Dimension Change Notification

1. Model series
RCE
2. Design change reason
Change the sensor design. Modify sensor dimension and sensing point.
3. Change descriptions

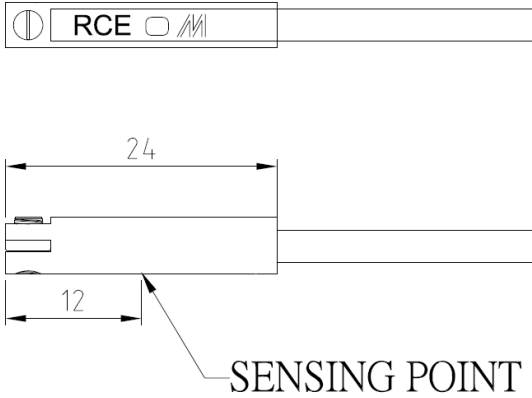
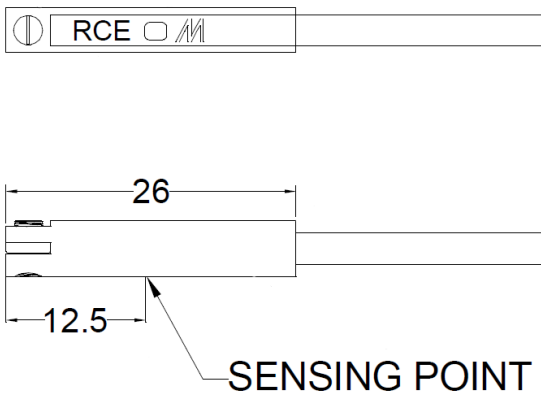
Before	After
 <p>24 12 SENSING POINT</p>	 <p>26 12.5 SENSING POINT</p>
